**Pollution Prevention Equipment; Final  
Rule**

[Docket No. USCG–2004–18939]

**Pollution Prevention Equipment****AGENCY:** Coast Guard, DHS.**ACTION:** Interim rule; request for comments.

FIGURE 162.050–17(d)—SAMPLE POINT

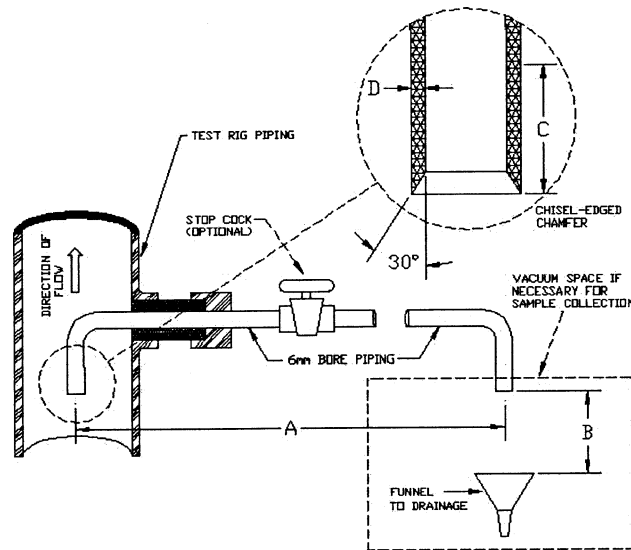
*Issue 57:* One commenter stated that the 30° chisel-edged chamfer in figure 162.050–17(d), Sample Point, should be around the outside perimeter instead of the inside perimeter of the sampler inlet to minimize disturbance of the sampling flow and to be consistent with MEPC.107(49).

*Response:* We agree and have corrected the chamfer illustrated in Figure 162.050–17(d).

Figure 3 - Tank of Test Fluid "C"

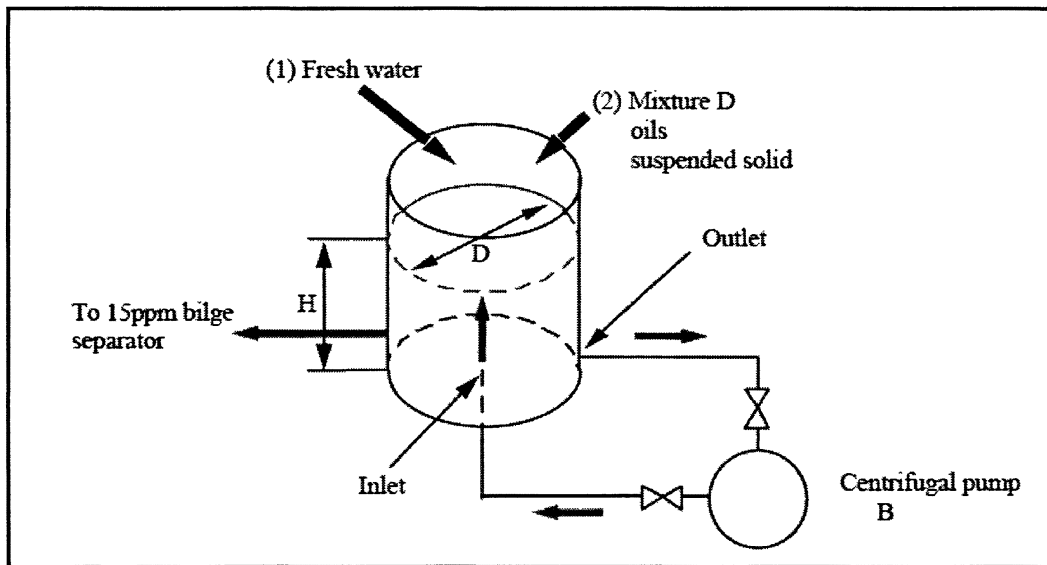
*Issue 60:* One commenter suggested including the specifications of the tank used for Test Fluid C per Figure 3 and notes 1 through 3 of paragraph 1.2.4 of Part I of the Annex to MEPC.107(49) as it would ensure consistent mixing of Test Fluid C by different test facilities.

*Response:* The Coast Guard agrees. Our proposed paragraph (b)(2) of 46 CFR 162.050–20 references a worksheet, figure 162.050–20, for determining Constituents of Test Fluid C. In response to this commenter's suggestion, we are adding MEPC's Figure 3 to that worksheet, and have inserted the notes as text in that worksheet.
